Flood Control Project Maintenance Levee Inspections

Fall 2020 Levee Maintenance Deficiency Summary Report

Reclamation District No. 0556 Upper Andrus

Levee Inspection Report By Mile - Fall 2020

Photo 1 of 1 : FA_2020_RD0556_18_24_20200910_00009.jpg

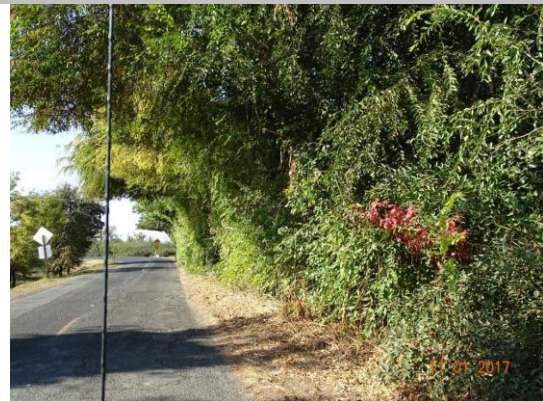
LM Start	0.87	Rating **	U	Issue No.	24
LM End	0.90	Issue Type +	En	Location *	LS
Category	Earthen Levee			GPS Latitude/Longitude	
				Start	End
Item	Vegetation			38.228820 °	38.228629 °
				-121.525853 °	-121.526165 °
DWR ID	DWR_RD0556_01_f_2017_24				
Comment Code					
V6 : Landscaping					
Inspector Comment

Trim/thin landscaping to allow inspection and access to levee slope and toe.

Photo 2 of 3 : UCIP_FA_2020_61398_88668.jpg

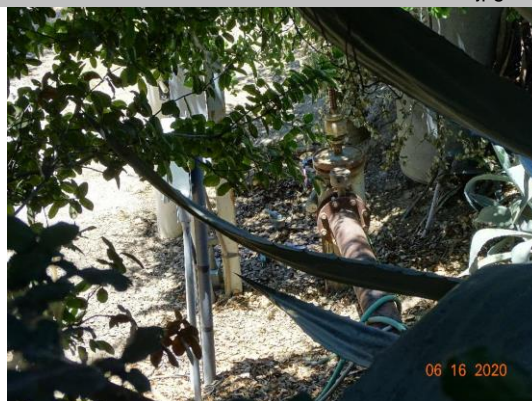
DS_ID:20825
FS_ID:61398
EP_NO: 13302
Repair Type: Non-Urgent
EVAL Issue: Levee Damage or Threat for Levee Damage
Crossing Status: Found
UCIP Comments: 06/16/2020 Record remains Non-Urgent. Concrete standpipe on landside has been replaced with a pressure tank. Unable to find a permit for modification. Depression around air release vent on landside shoulder about 2 feet in diameter and 1/2-foot deep. (O.Yakimov - DWR UCIP)
05/27/2015 Seal beneath siphon breaker off LS toe leaking. Rodent activity near crown off LS shoulder. Need to contact owner about leaky seal. Dense vegetation prevented inspection of WS slope. (K.Fazel - DWR UCIP)
FIELD_STRUCT_DESC: 6-inch steel irrigation discharge pipe and 2-inch galvanized iron electrical conduit through the levee, 2 feet below the crown. Siphon valve on the landside (LS) shoulder. Pump, gate valve, and pressure tank at the LS toe. Service pole and electrical box at the LS toe. 6-inch polyvinyl chloride (PVC) standpipe adjacent to the pipe off the LS toe. (Plans to install a 6-inch irrigation pipe and electrical conduit through the levee authorized under Permit No. 13302, 1981 - Kaydix Ranch). [Additional Reference(s): DWR Levee Log. USACE Sacramento O&M Manual 103, June 1954, (Station "R" 540+85), invert elevation 16.3 feet].

Photo 1 of 3 : UCIP_FA_2020_61459_88910.jpg

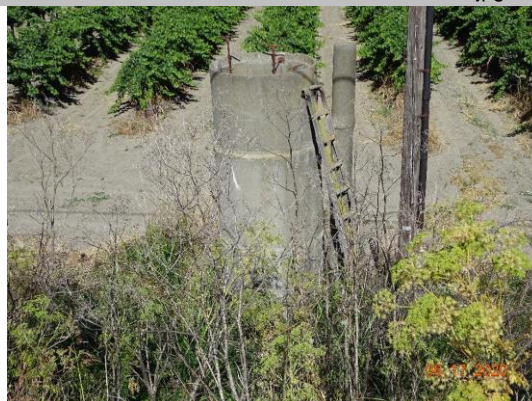
LM Start	2.13	Rating **	M	Issue No.	82
LM End	2.13	Issue Type +	En	Location *	
Category	Supplemental			GPS Latitude/Longitude	
				Start	End
Item	DWR UCIP Field Study			38.222560 °	38.222560 °
				-121.544485 °	-121.544485 °
DWR ID	20830				
Comment Code					
Inspector Comment

DS_ID:20830
FS_ID:61459
EP_NO: 2392
Repair Type: Non-Urgent
EVAL Issue: Limited Inspection/No UCIP Evaluation
Crossing Status: Found
UCIP Comments: 06/17/2020 Record remains Non-Urgent. Unable to evaluate levee slopes condition due to overgrown vegetation. (O.Yakimov - DWR UCIP)
05/27/2015 Hole and exposed depression adjacent to pipe at LS. Dense vegetation on WS and LS limited visibility. (K.Fazel - DWR UCIP)
FIELD_STRUCT_DESC: 12-inch steel irrigation discharge pipe through the levee, 3 feet below the crown. Slant pump on the waterside (WS) bank. 1-inch electrical conduit through the levee, beside the 12-inch pipe, visible on the WS. Service pole and two standpipes at the landside (LS) toe. One of the two standpipes is 6 inches. (Plans for the installation of a pumping plant and a steel pipe through the levee authorized under Permit No. 2392, 1956 - Loyal D. Mealer). [Additional Reference(s): DWR Levee Log].

Photo 2 of 3 : UCIP_FA_2020_61500_89035.jpg

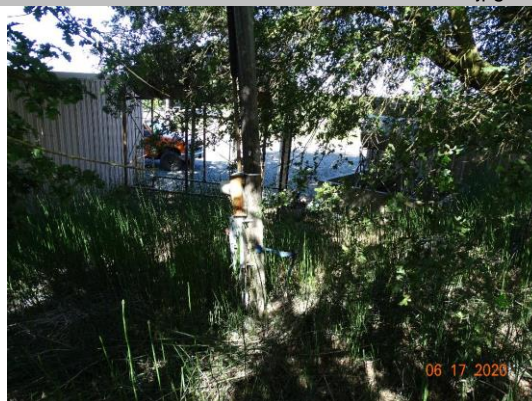
DS_ID:20833
 FS_ID:61500
 EP_NO: 11167
 Repair Type: Non-Urgent
 EVAL Issue: Unauthorized Modification or Non-Compliant Permit
 Crossing Status: Found
 UCIP Comments: 06/17/2020 Record is Non-Urgent. Unable to find a permit for sleeving 10-inch pipe through 12-inch pipe. Unauthorized encroachment recorded in Levee Log prior to 2011. Need to have CVFPB review ABO and determine current owner. (O.Yakimov - DWR UCIP)
 FIELD_STRUCT_DESC: 10-inch steel irrigation pipe sleeved through 12-inch steel pipe through levee, 4.0 feet below crown. Slant pump and gate valve on bank. 2-inch conduit through the levee 2 feet below crown. Service pole at landward toe. (12-inch pipe [HLM 2.70] authorized under Automatic Board Order (ABO) issued as Permit No. 11167, 1975 - Russel G. Graham).
 FS Date: 6/17/2020

Photo 1 of 1 : FA_2020_RD0556_18_48_20200910_00030.jpg

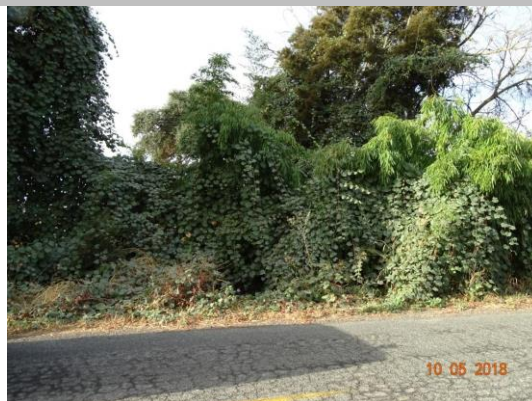
LM Start	2.72	Rating **	U	Issue No.	48
LM End	2.72	Issue Type +	En	Location *	LS
Category	Earthen Levee			GPS Latitude/Longitude	
				Start	End
Item	Vegetation			38.215085 °	38.215085 °
				-121.540724 °	-121.540724 °
DWR ID	DWR_RD0556_01_f_2018_48				
Comment Code					
V6 : Landscaping					
Inspector Comment					
Remove wild grapes and bamboo from landside.

Photo 1 of 1 : FA_2020_RD0556_19_25_20200909_00010.jpg

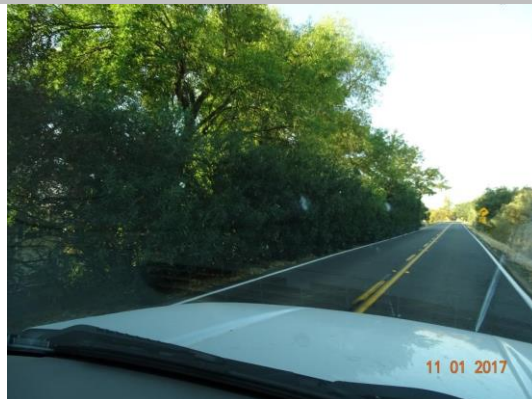
LM Start	0.53	Rating **	U	Issue No.	25
LM End	0.55	Issue Type +	En	Location *	LS
Category	Earthen Levee			GPS Latitude/Longitude	
				Start	End
Item	Vegetation			38.237833 °	38.237810 °
				-121.527766 °	-121.528182 °
DWR ID	DWR_RD0556_02_f_2017_25				
Comment Code					
V6 : Landscaping					
Inspector Comment					
Trim/thin oleanders on the landside of the levee.

Photo 1 of 1 : FA_2020_RD0556_19_46_20200909_00028.jpg

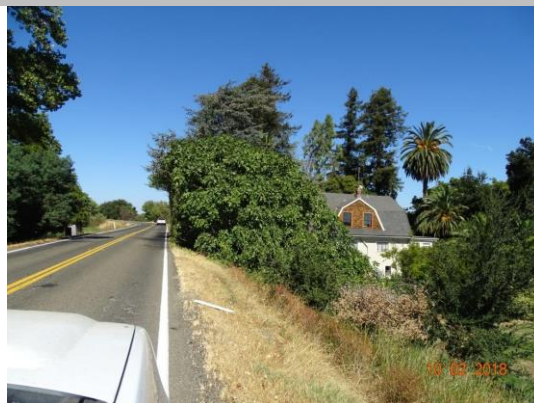
LM Start	2.86	Rating **	M	Issue No.	46
LM End	2.86	Issue Type +	En	Location *	LS
Category	Earthen Levee			GPS Latitude/Longitude	
				Start	End
Item	Vegetation			38.229195 °	38.229195 °
				-121.555337 °	-121.555337 °
DWR ID	DWR_RD0556_02_f _ 2019_46				
Comment Code					
V6 : Landscaping					
Inspector Comment

Photo 1 of 1 : FA_2020_RD0556_19_16_20200909_00004.jpg

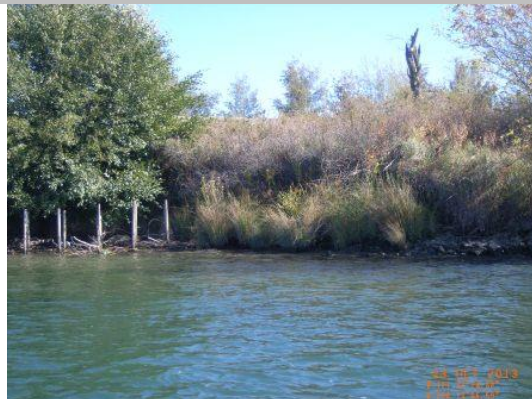
LM Start	3.58	Rating **	M	Issue No.	16
LM End	3.64	Issue Type +	Ma	Location *	WS
Category	Supplemental			GPS Latitude/Longitude	
				Start	End
Item	2017 USACE Erosion Survey			38.218951 °	38.218104 °
				-121.556689 °	-121.556819 °
DWR ID	DWR_RD0556_02_f_2018_16				
Comment Code					
Inspector Comment					
2017 Site ID: SAC 22.7 L					
Status: Eroding					
2017 Field Notes: Minor new erosion at toe.					
Site History: 1997 - Scallops into berm and very close to levee toe.					
2005 - Brush boxes present. 2011 - New toe scour and freshly fallen tree. 2012 - New tree popout has taken significant portion of soil out of the levee.

Photo 1 of 1 : FA_2020_RD0556_19_79_20200911_00067.jpg

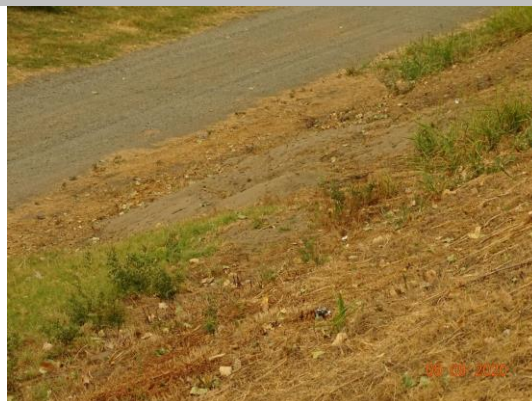
LM Start	5.64	Rating **	U	Issue No.	79
LM End	5.64	Issue Type +	Ma	Location *	LS
Category	Earthen Levee			GPS Latitude/Longitude	
				Start	End
Item	Animal Control			38.192237 °	38.192237 °
				-121.566368 °	-121.566368 °
DWR ID	DWR_RD0556_02_f_2018_79				
Comment Code					
A3 : No rodents visible, but rodent burrows visible; need to backfill and compact or grout burrows.					
Inspector Comment					
More than 2 cubic feet of soil was removed between the two large burrow holes.
